## Staff Report

**To:** City Council  
**From:** Daren Fluke, Consulting City Planner  
**Report:** March 28, 2025  
**Hearing:** April 16, 2025  
**Item:** PS23-0001: Daher #1 Subdivision  
**Applicant:** Kodiak Aircraft Company / Quest Aircraft – C/O Dave Schuck

Figure 3 - Preliminary Plat

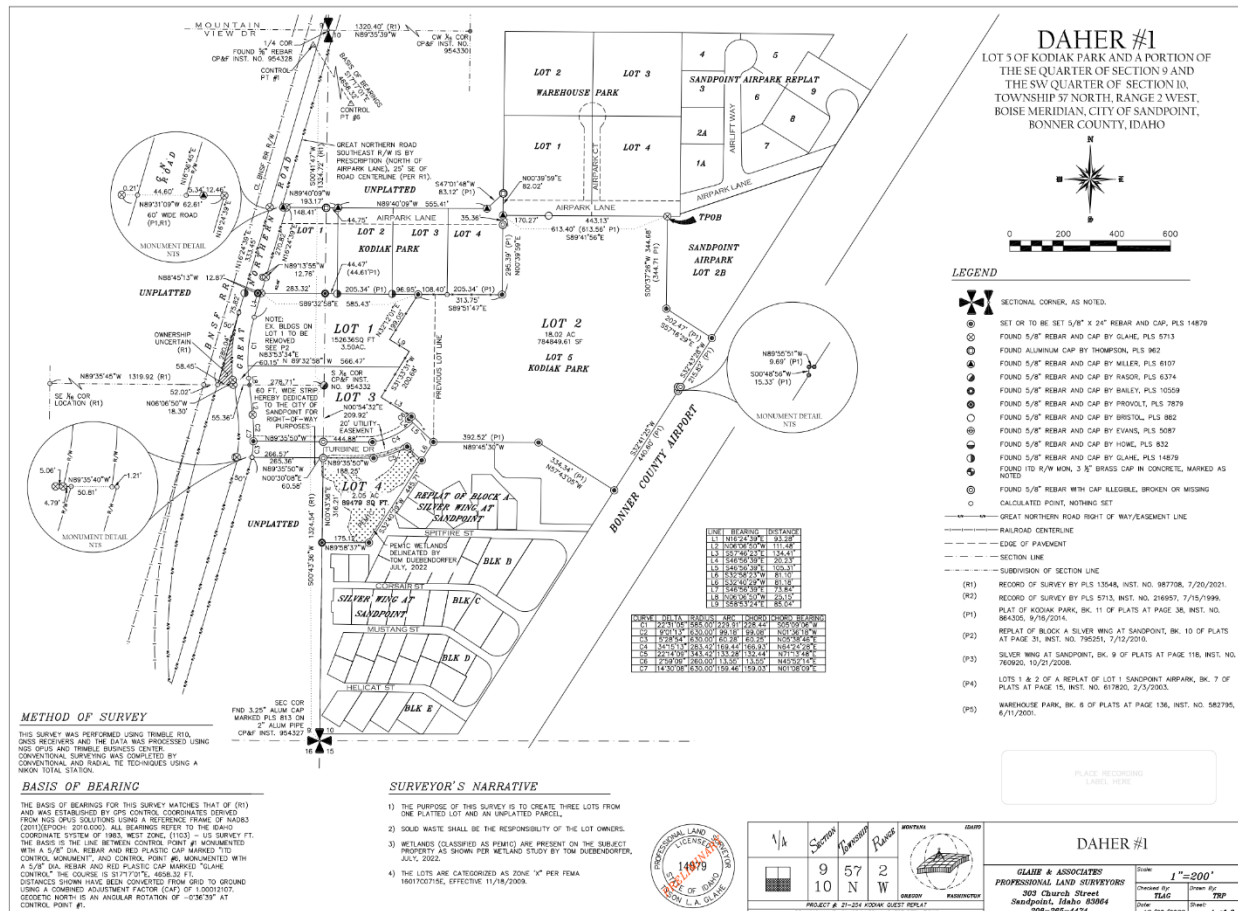
**Findings:** All relevant requirements of §10-1-C are present on the preliminary plat and/or within the application materials.

**Findings:** The preliminary plat and application materials generally show compliance with the required improvements. A sewer main extension will be required at the time of building permit in order to serve any new development on any lot. A 6-foot-wide asphalt path along the frontage of the newly dedicated Turbine Drive right of way will be required at the time of building permit on any lot. Before final plat approval, a development agreement shall be recorded between the applicant and the City of Sandpoint, describing these required improvements. A fire turnaround, meeting the requirements of the International Fire Code and approved by the City of Sandpoint, will be required at the east end of Turbine Drive before final plat approval.

**Findings:** The subdivision application is requesting that Turbine Drive be dedicated as 60' public right-of-way to provide frontage and access to Lot 2 and 4. Lot 1 will have access from Great Northern Road.

**Findings:** The preliminary plat includes the dedication of Turbine Drive (an existing private road) as a public right-of-way. A fire turnaround, meeting the requirements of the International Fire Code and approved by the City of Sandpoint, will be required at the east end of Turbine Drive before final plat approval.

**Findings:** The proposed lots as dimensioned on the preliminary plat meet the lot size and frontage requirements and any future land uses and buildings will be regulated through the zoning and/or building permit processes for compliance with all applicable standards of Chapter 9-3.

1. Compliance with Section 10-1-5, 10-1-6, and 10-1-7 of the Sandpoint City Code are required prior to approval of the final plat.
2. Construction of a fire turnaround, meeting the requirements of the International Fire Code and approved by the City of Sandpoint, providing frontage and access to Lots 2, 3, 4 and the Silver Wing at Sandpoint Subdivision, will be required at the east end of Turbine Drive before final plat approval. The existing gate leading into Silver Wing at Sandpoint may need to be relocated, at the expense of the applicant, so that it is situated or located outside of the final-right-of-way for Turbine Drive.
3. Dedication of the needed right-of-way for the expansion of Great Northern Road, including a separated, 12-foot multi-use path is required at such time as the needed right-of-way is known and/or required for

4. The existing buildings on Lot 3 shall be demolished and removed pursuant to a demolition permit prior to approval of the final plat.
5. The final plat shall include the wetland as delineated on Lot 4 on the preliminary plat and a note stating: "Development of Lot 4 is subject to the issuance of a permit issued by the Army Corp of Engineers. No grading, drainage, or building permits may be issued for Lot 4 without the express written approval of the Army Corps of Engineers."
6. Prior to the approval of the final plat the applicant shall enter into a construction agreement with the City agreeing to fund, design, and construct the required sewer main extension and 6-foot-wide asphalt path on the north side of the newly dedicated Turbine Drive right-of-way. Said improvements are required to be constructed prior to the issuance of building permits on any lot within the plat.
